# STATE OF OHIO DEPARTMENT OF TRANSPORTATION

## DEF-24-11.35

CONSTRUCT A NEW 0.42 MILE 2-LANE OVERPASS AT THE US24/CR 185 AT-GRADE INTERSECTION & REMOVE CURRENT INTERSECTION. THE PROJECT CONSISTS OF RAISING CR 185 OVER US24 ON THE EXISTING ALIGNMENT, CONSTRUCTING A NEW 2-SPAN BRIDGE & REMOVING INTERSECTION PAVEMENT ON US 24 & RESTORING US 24 TO A 4-LANE DIVIDED FACILITY.

ADDENDUM	NUMBER	DATE	DESCRIPTION
	1	02/14/2025	UPDATED DATE

CULVERT DETAILS  
 STA. 121+85.55

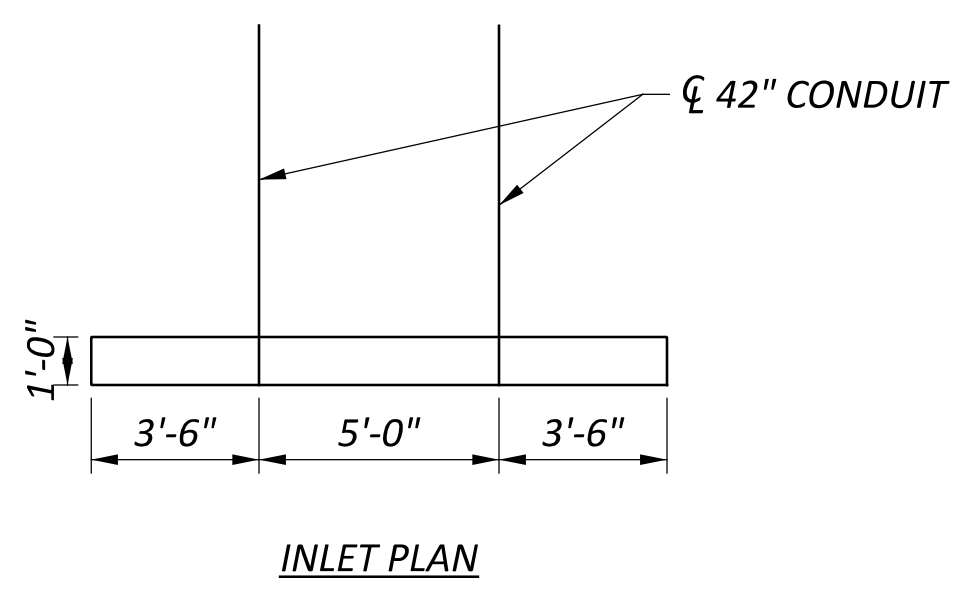
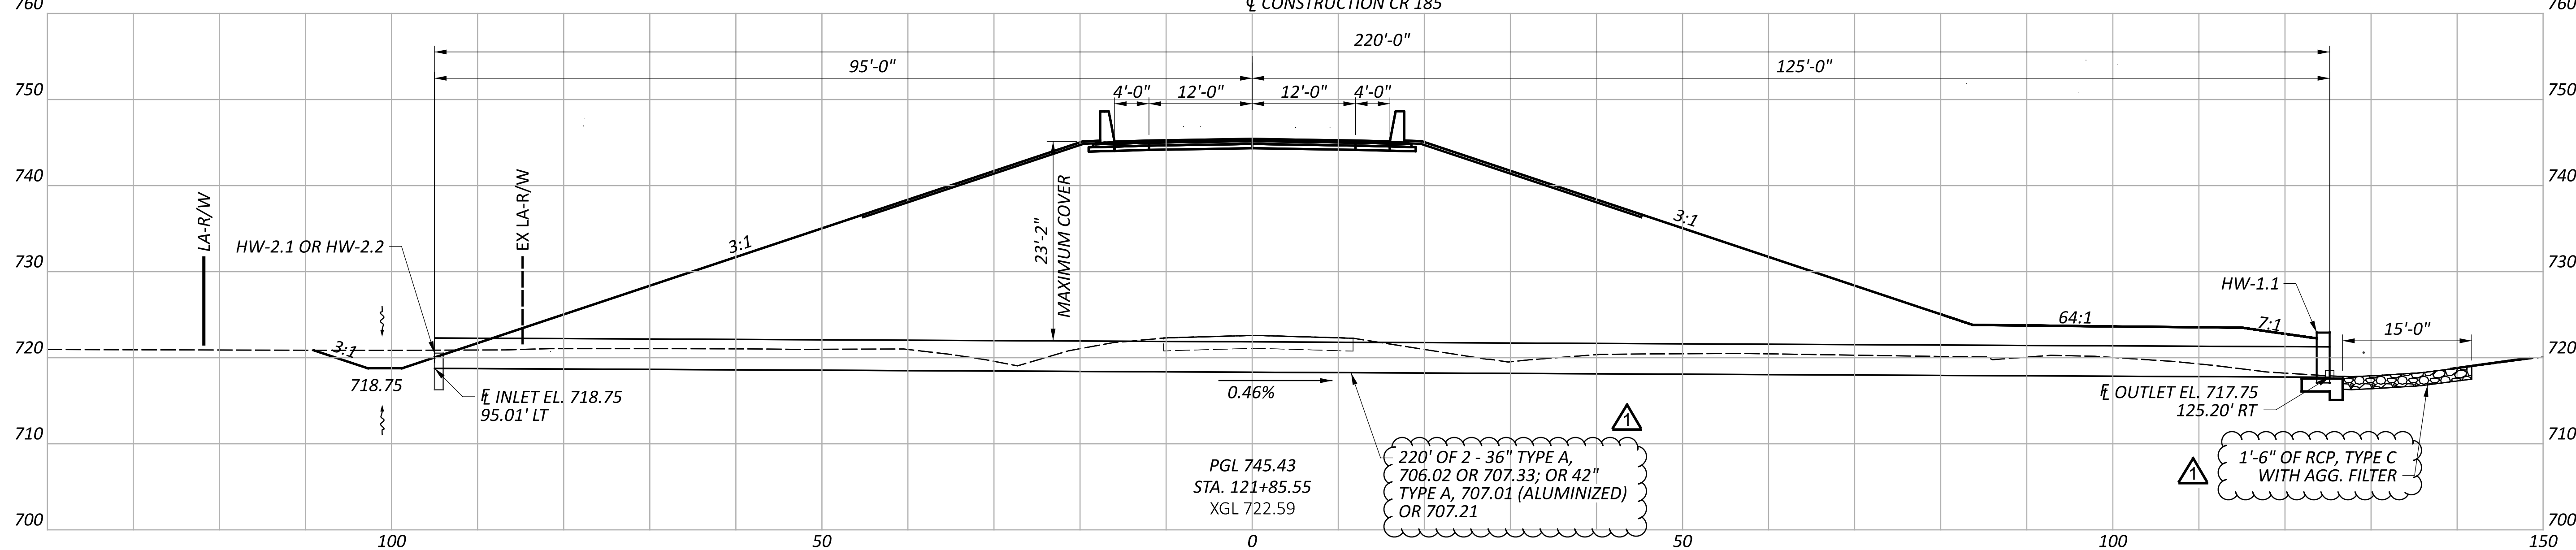
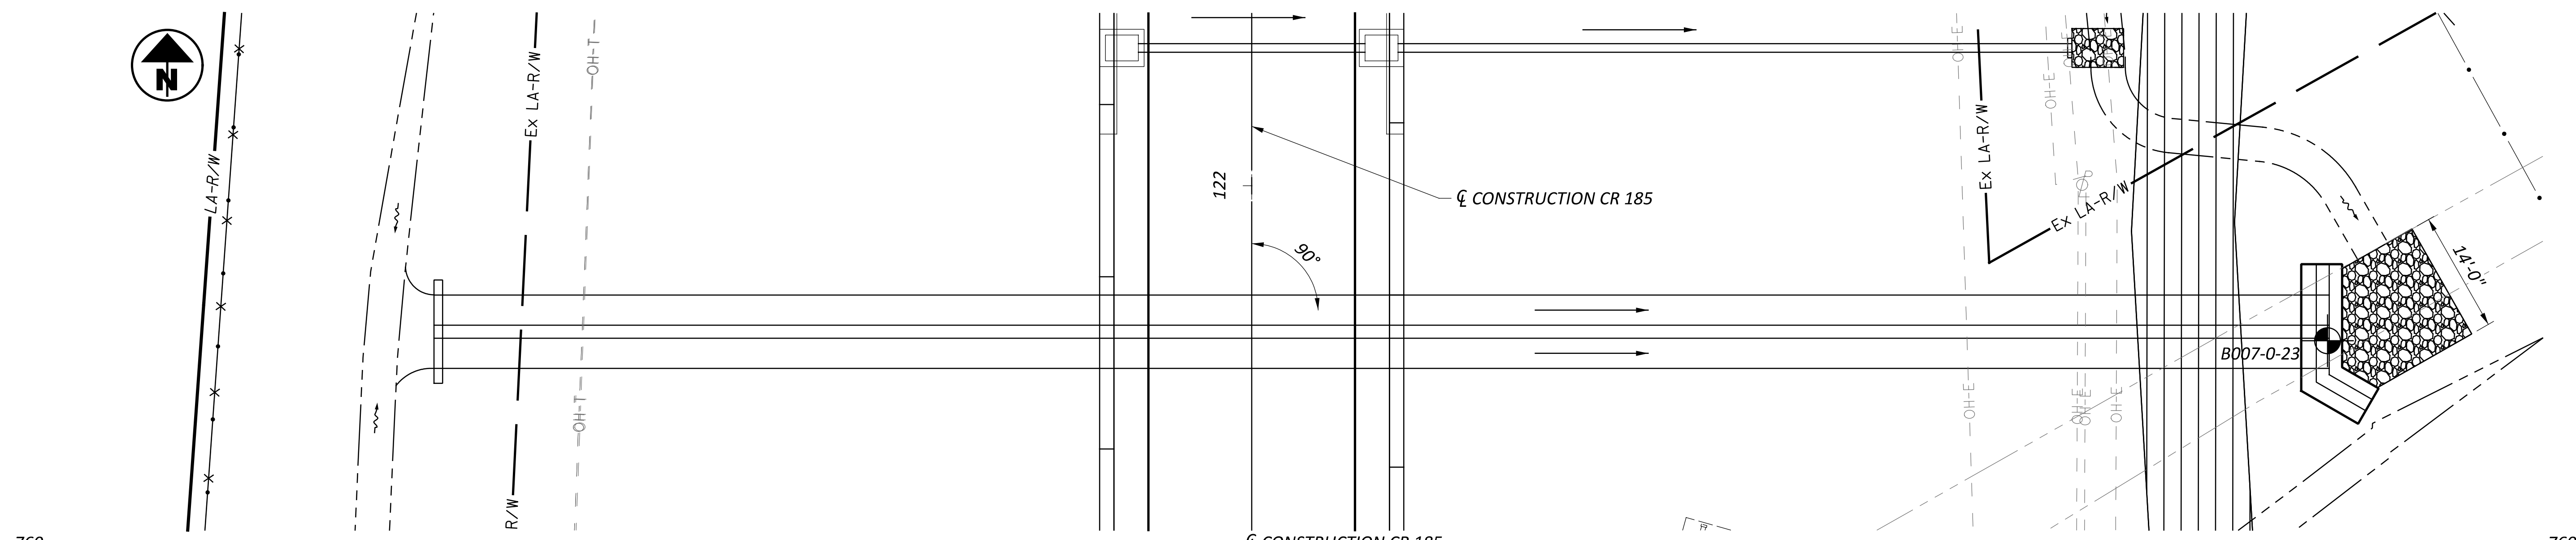
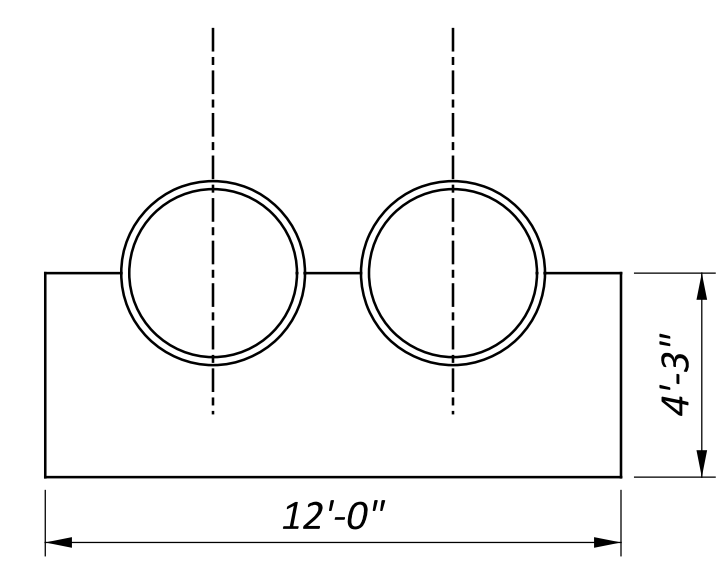
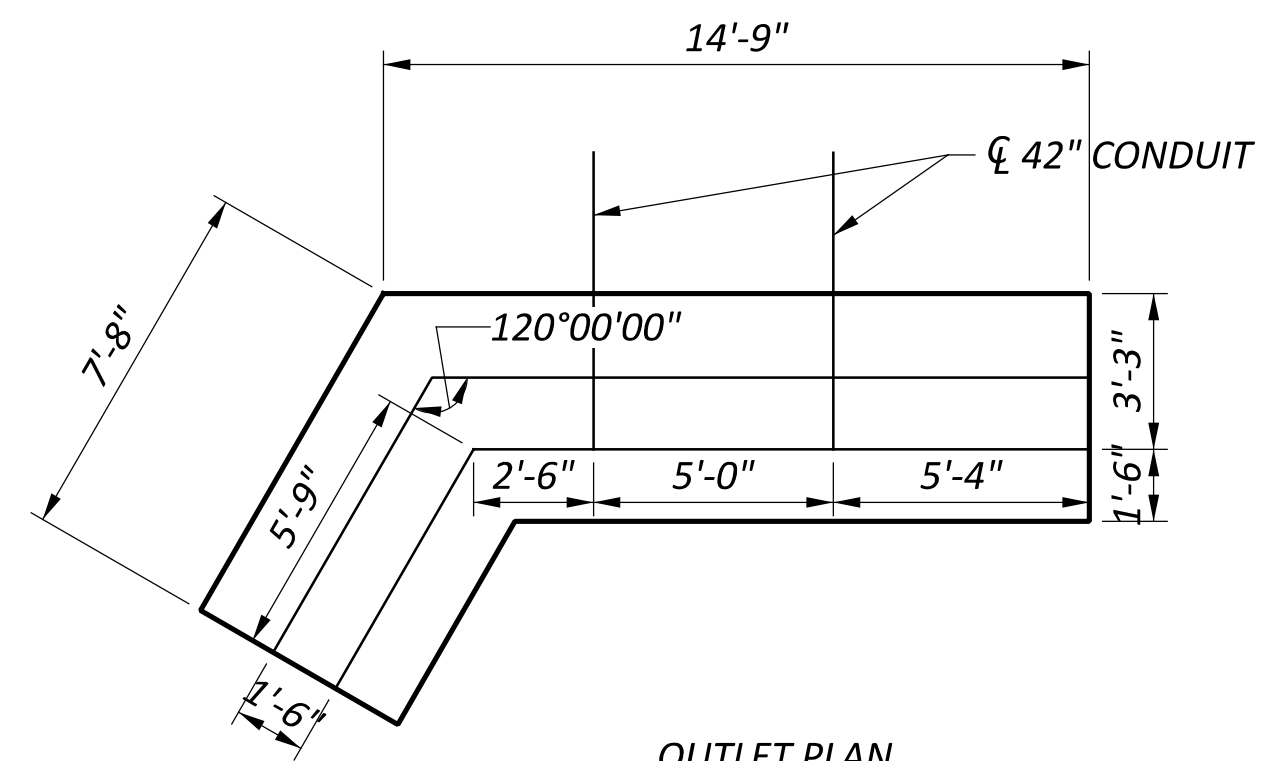
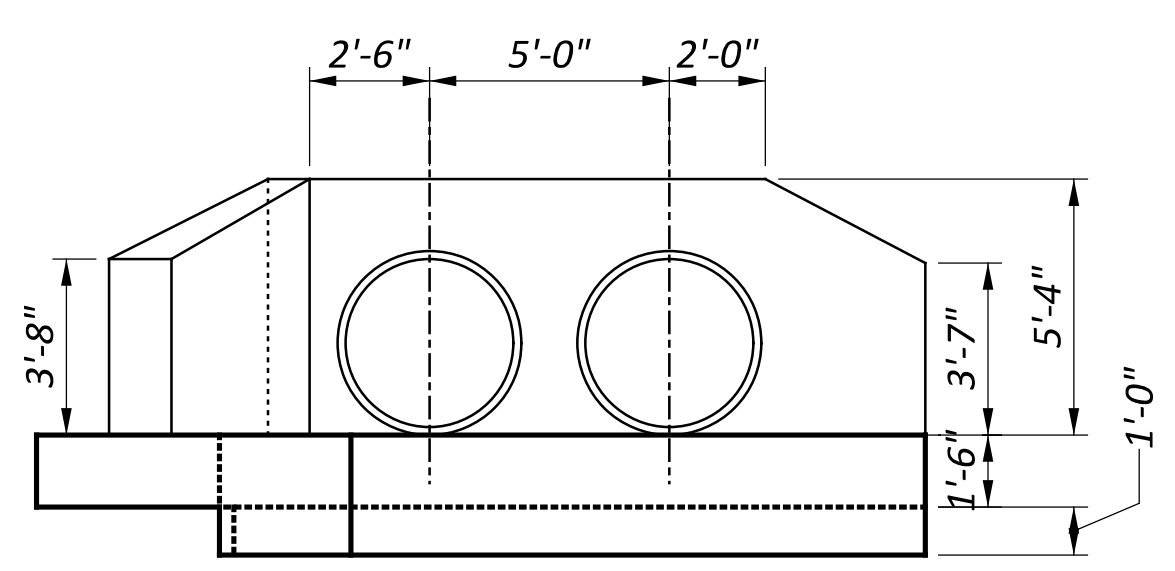
APPENDIX	NUMBER	DATE	DESCRIPTION
	▲	02/14/2025	REVISED CULVERT INFORMATION

PROPOSED STRUCTURE	
TYPE:	TWO - 36" CONDUIT, TYPE A, 706.02 OR 707.33; OR 42" TYPE A, 707.01 (ALUMINIZED) OR 707.21
SKEW:	0°
ALIGNMENT:	TANGENT
CFN:	1996360 & 1996361

**CULVERT DETAILS**  
**STA. 124+26.00**

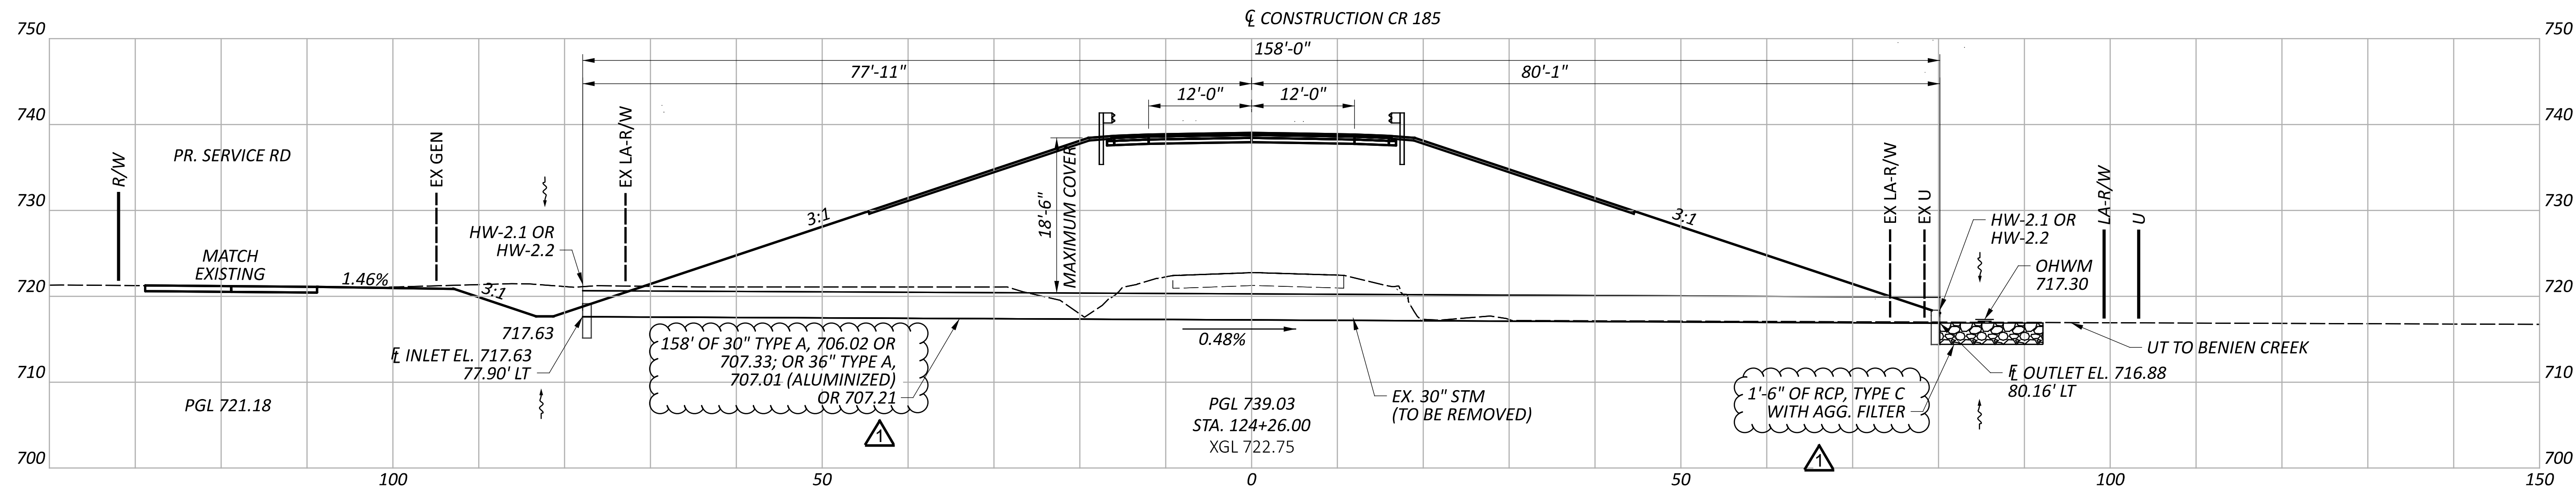
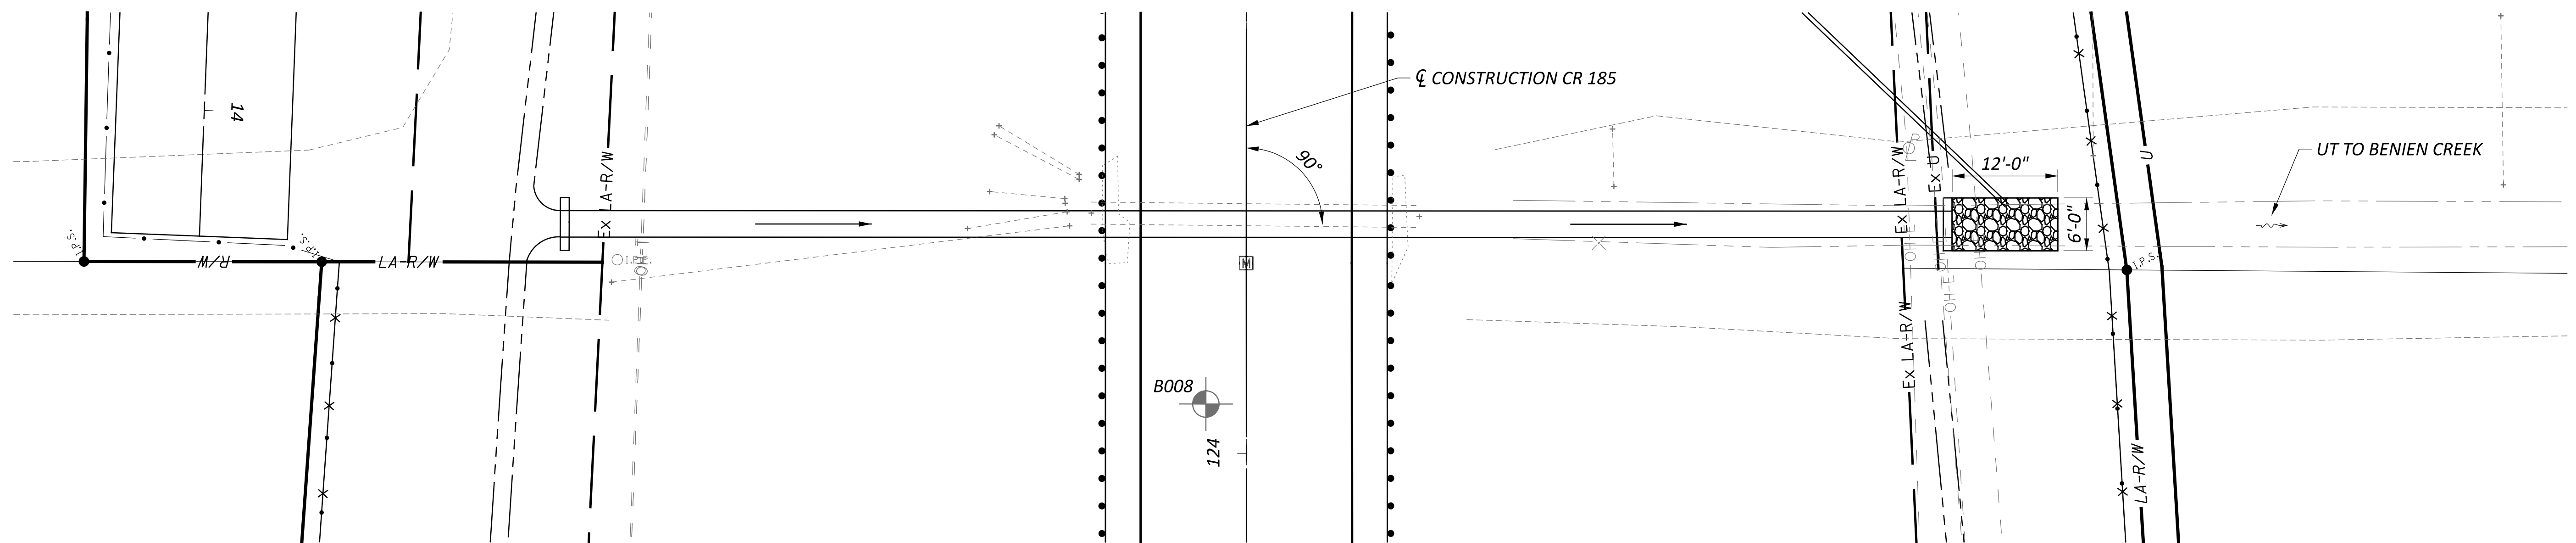
ADDENDUM	NUMBER	DATE	DESCRIPTION
	1	02/14/2025	REVISED CULVERT INFORMATION
